**From:** James Park  
**To:** PHILLIP BARR  
**Date:** 7/12/05 10:37AM  
**Subject:** Re: Fw: The Ogallala Aquifer

In response to your email concerning the extent of the Ogallala Aquifer, the figure you provided indicates that the Ogallala Formation extends well south of the proposed NEF site. Such a conclusion may not be supported based on the large scale used in the figure. I point you to the two attached figures taken from USGS websites. The first is from the USGS Groundwater Atlas website <[http://capp.water.usgs.gov/gwa/ch\\_c/C-text5.html](http://capp.water.usgs.gov/gwa/ch_c/C-text5.html)> discussion of the High Plains Aquifer (also known as the Ogallala Aquifer), and the second figure is from the USGS High Plains Regional Ground Water (HPGW) Study website <[http://co.water.usgs.gov/nawqa/hpgw/HPGW\\_home.html](http://co.water.usgs.gov/nawqa/hpgw/HPGW_home.html)>. Both figures show the southern boundary of the Ogallala Aquifer north of the proposed NEF site.

**Figure 66.** The High Plains aquifer extends through an area of about 174,000 square miles in parts of eight States.

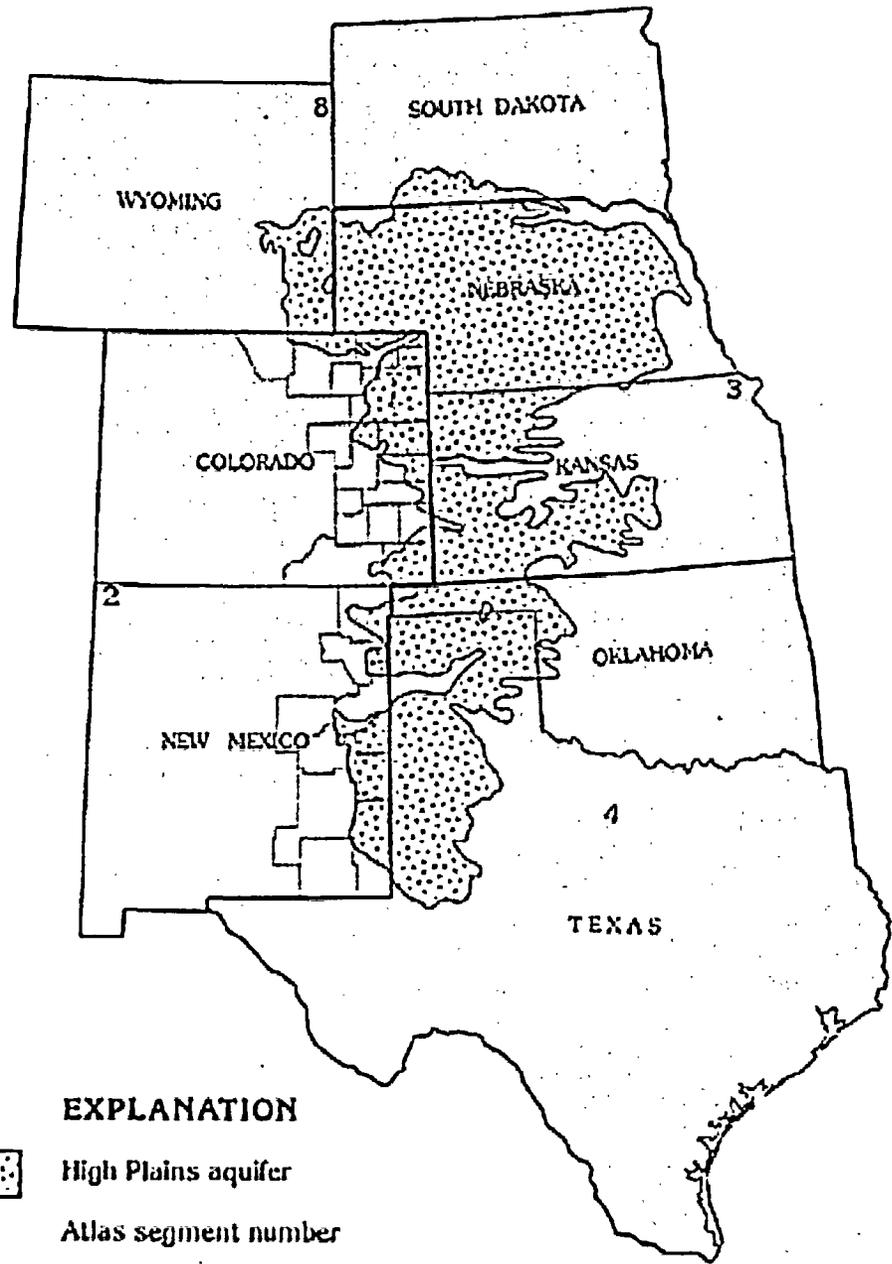
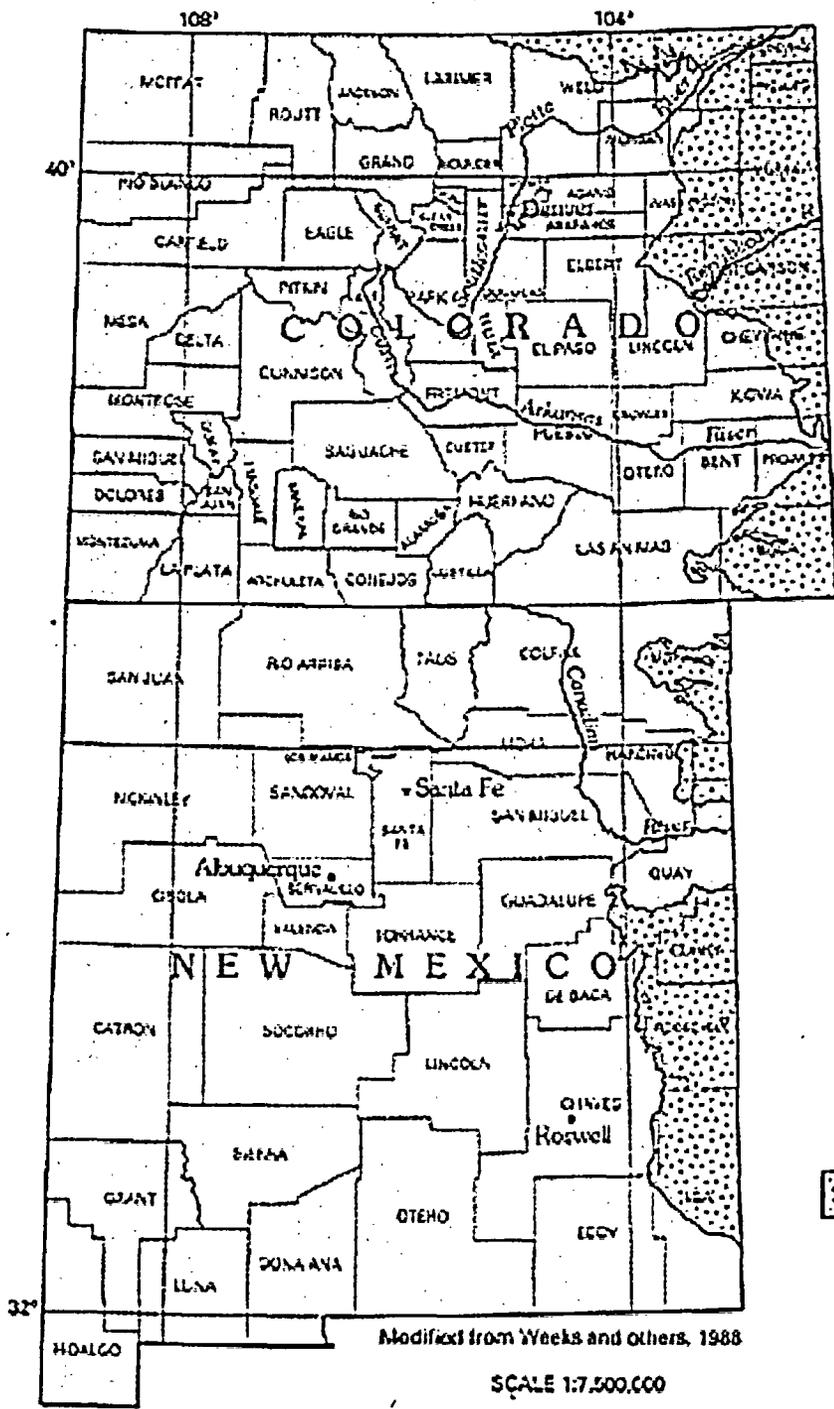
>>> "PHILLIP BARR" <[pharb2@msn.com](mailto:pharb2@msn.com)> 07/02/05 09:30AM >>>  
Could the NRC explain the differences between the Texas map and the NRC map of the aquifer.  
No comment from the state of Texas.  
They just took the map off their site.

Based on site investigations at the proposed NEF which have not encountered the Ogallala Formation and the NRC staff's independent evaluations, the NRC staff has concluded that the Ogallala Aquifer does not extend below the proposed NEF site.
